<input type="checkbox"/> Sidewalk Waiver (Form V2)		
SITE PLANS		<input type="checkbox"/> Waiver to IDO (Form V2)	APPEAL
<input type="checkbox"/> DRB Site Plan (Form P2)	<input type="checkbox"/> Waiver to DPM (Form V2)	<input type="checkbox"/> Decision of DRB (Form A)	
BRIEF DESCRIPTION OF REQUEST			
Minor Amendment to Infrastructure List Approval

Reference: **Overture Andalucia**; PR-2020-003658
Tract 4, North Andalucia at La Luz

Subject: Request & Justification for Revising the Approved Infrastructure List

Variance: Maximum Perimeter Wall Height

Section study Sheet Pile Wall Section

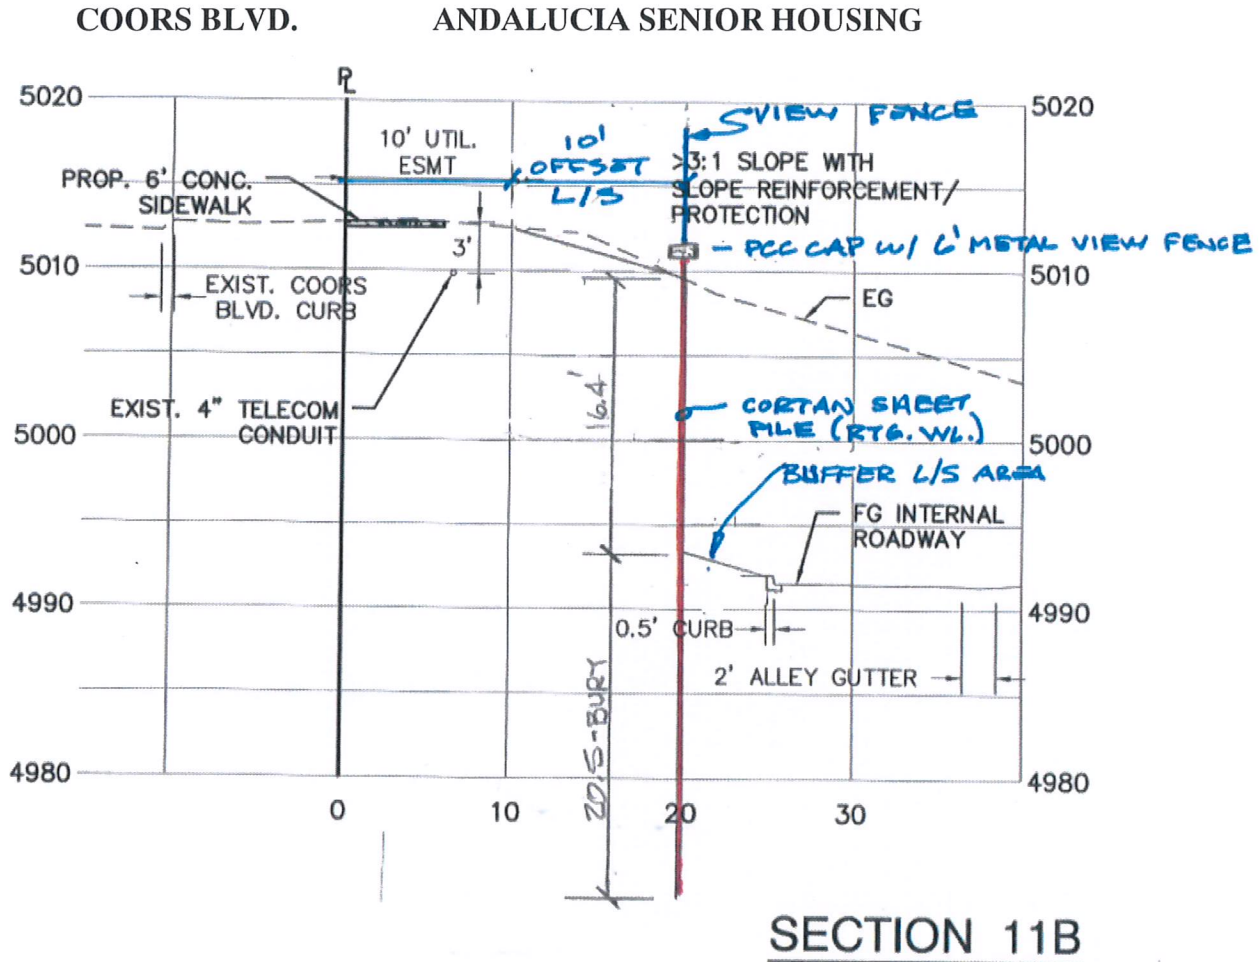
Following the Geotechnical Engineer's recommendations, a sheet pile wall system was researched, designed, and deemed constructible for this project. The proposed system would protect the existing improvements within the Coors Blvd. Right-of-Way as well as the existing underground utilities within the adjacent 10' P.U.E.

A section through the proposed sheet pile wall is provided below.

Proposed location of Sheet Pile Wall (retaining between 10' and 17' vertical)

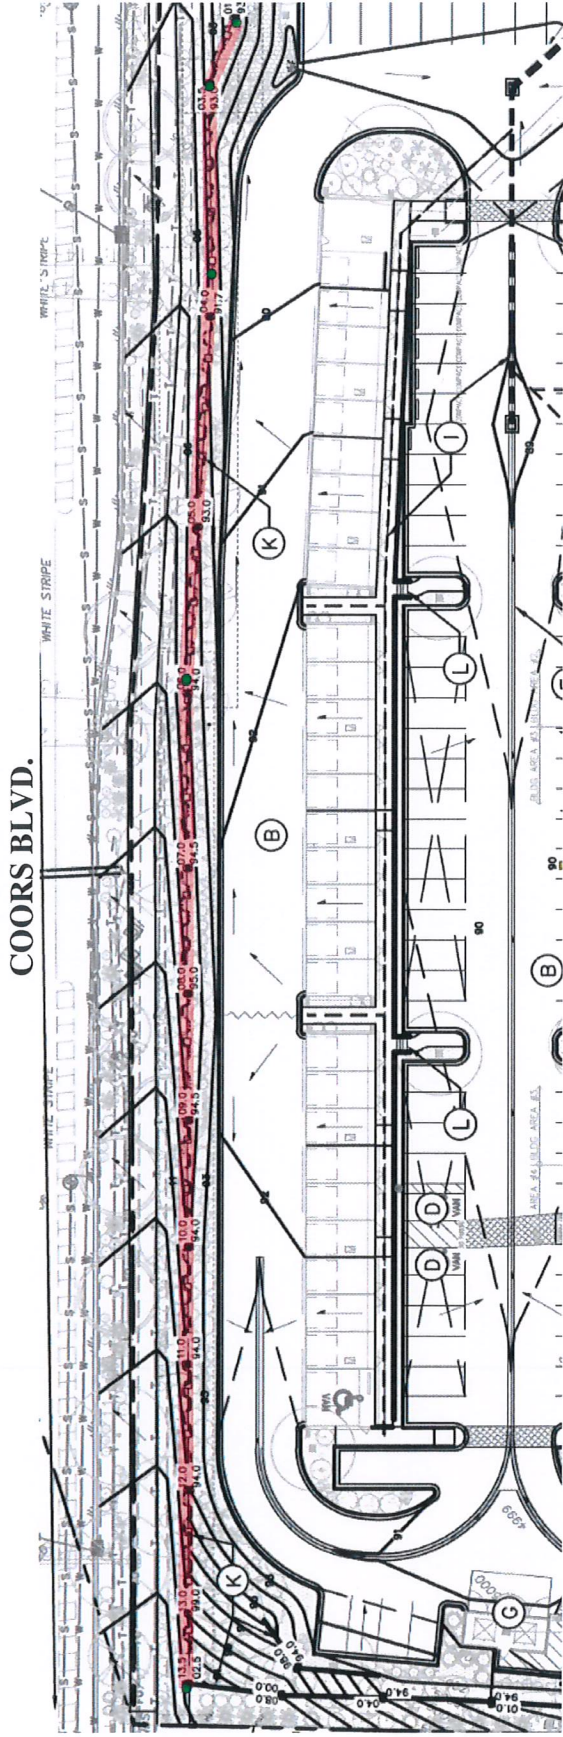
The following page identifies the proposed extent of sheet pile wall. This wall system would be utilized only at locations that would exceed the allowable 10' high retaining wall height.

The remainder of the proposed on-site retaining walls will be constructed with a maximum retaining height of 10.0'. Additional height (1'-2'±) will be added for drainage control. Therefore, we request a variance to the proposed maximum height of the non-sheet pile perimeter wall to 12' with a maximum retaining of 10'.

Safety precautions such as guardrails will be installed along the entire length of the upper level of perimeter walls (sheet pile and standard walls).

Exhibit A:
 Section study
 Tiered Retaining Wall (CMU or Cast-in-place Concrete)

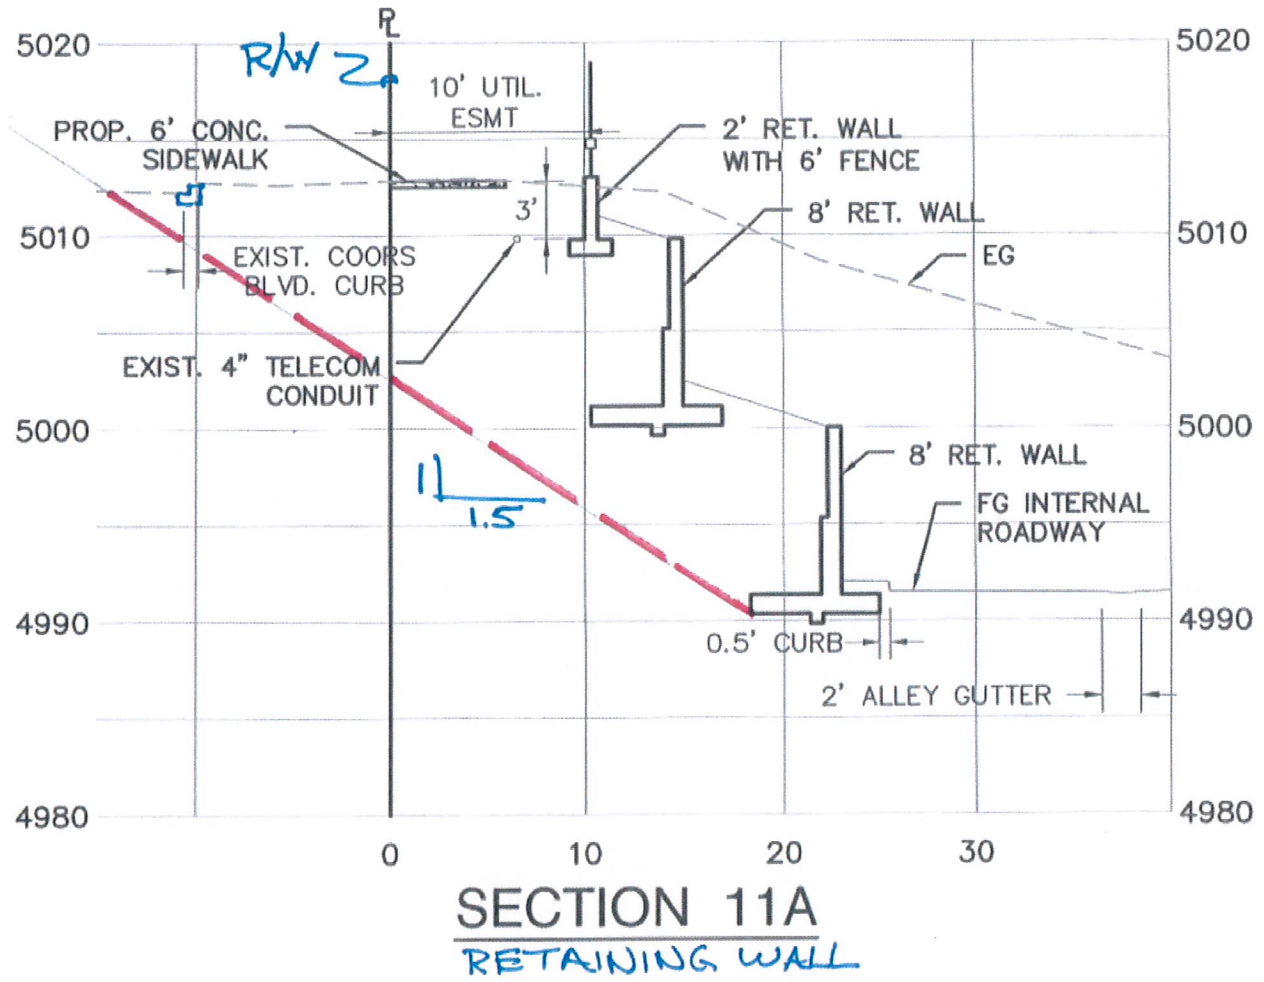
3. The initial perimeter wall systems was designed as a single, two & three tier CMU wall system;
4. The project Geo-Tech consultant warned that the existing soils would not hold when cut back at a slope greater than 1.5 : 1. Based on the projected cross-section, the cut-slope would extend into the Coors Blvd. north bound driving lane.

One major adjustment is to the proposed perimeter retaining walls along the Coors Blvd. Right-of-way (ROW). Based on the recommendations of Mike Anderson, PE, the Geotechnical Department Manager at Terracon Consultants Inc., constructing a CMU tiered wall or a Mechanically Stabilized Earth (MSE) retaining wall along Coors Blvd. would not be feasible due to the onsite existing soil and because the extent of excavation required to construct these walls would daylight a significant distance into the Coors Blvd. ROW in order to properly and safely install the walls and the soil reinforcement geogrid (see Exhibits A and B for sections showing conflict with Coors Blvd. ROW.)

Exhibit B:
Section study
Mechanically Stabilized Earth (MSE) retaining wall (Keystone)

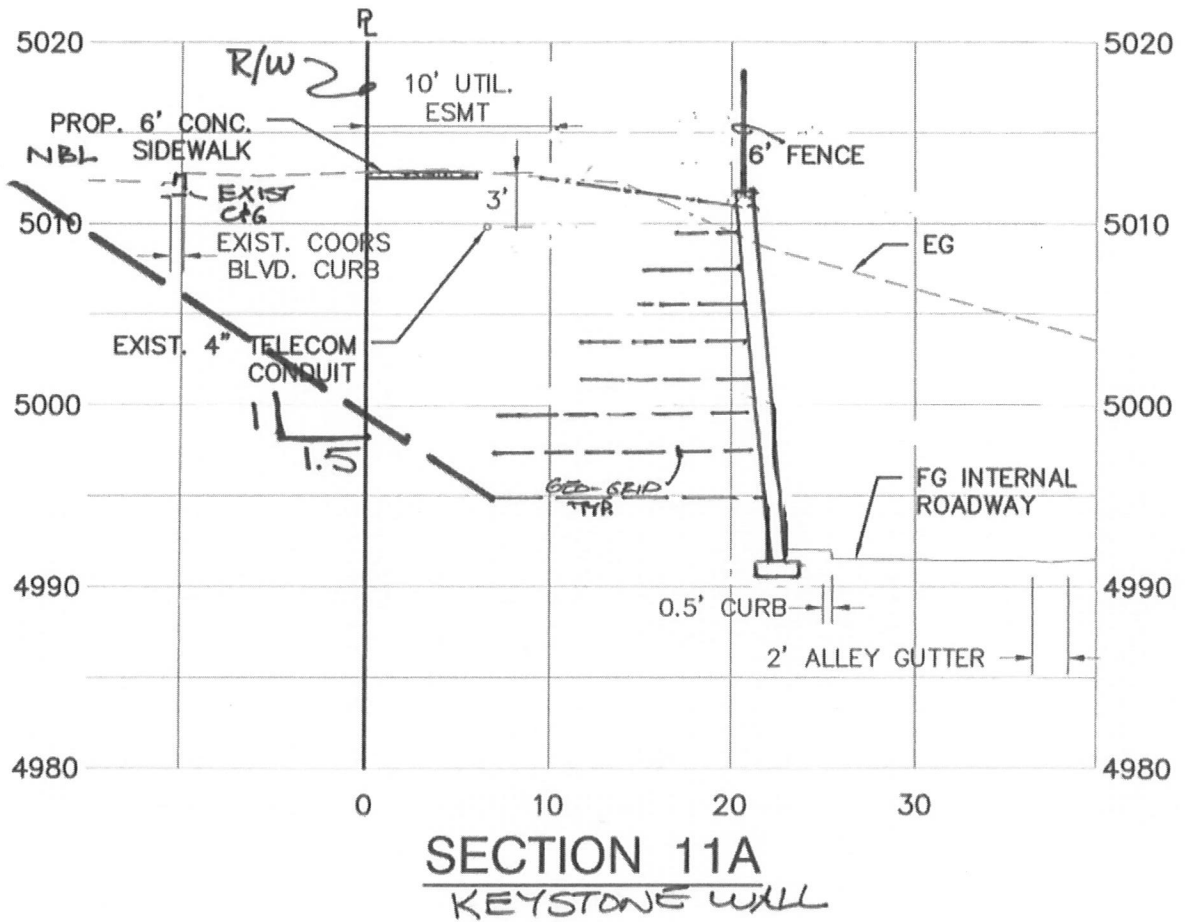
Although the geogrid would be contained within the property, there would still need to be a temporary excavation face/slope that would need to be maintained during geogrid placement/construction, which would likely not be at a stable sloped configuration given the ROW restrictions.
